# **PREFERRED PROJECT AND RESPONSE TO SUBMISSIONS REPORT**

Newcastle Gas Storage Facility Project  
Major Project Application Number 10-0133

September 2011

CR 6023\_10\_v3

FIGURE 1  
SKETCH CI-0002

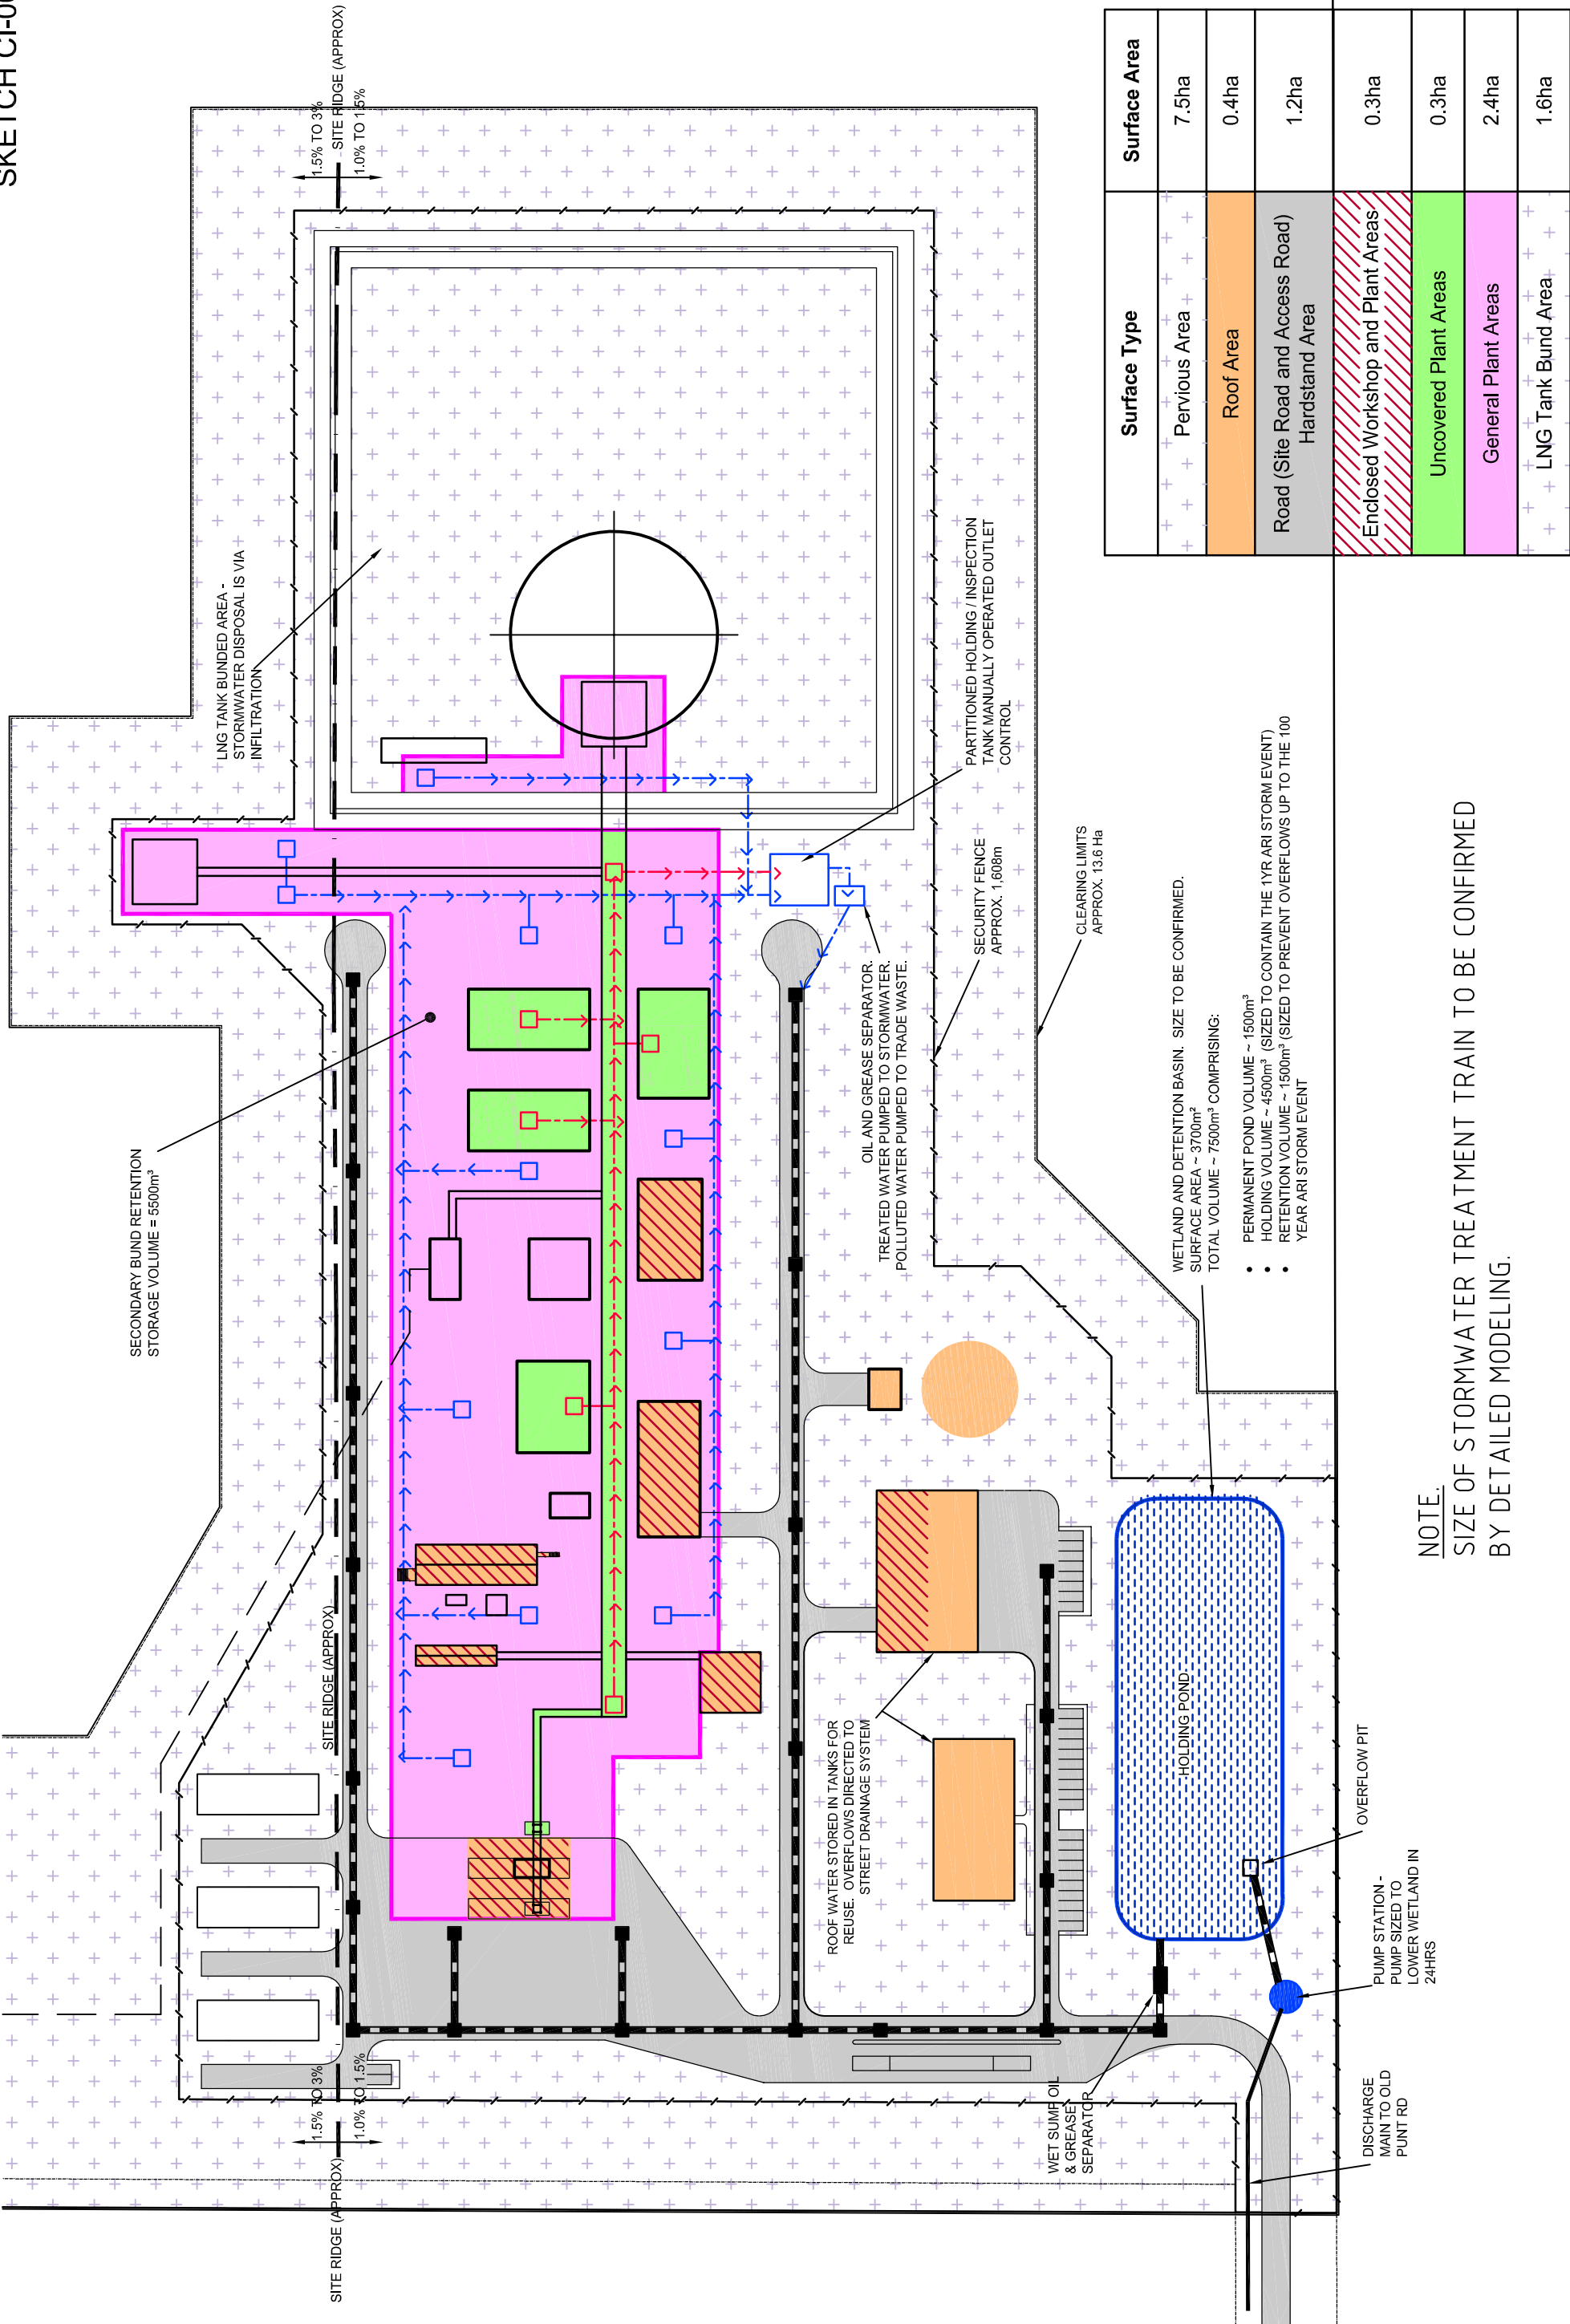
**Response to Newcastle City Council Comments  
Hexham Receiving Station**

NOTE.  
SIZE OF STORMWATER TREATMENT TRAIN TO BE CONFIRMED  
BY DETAILED MODELING.
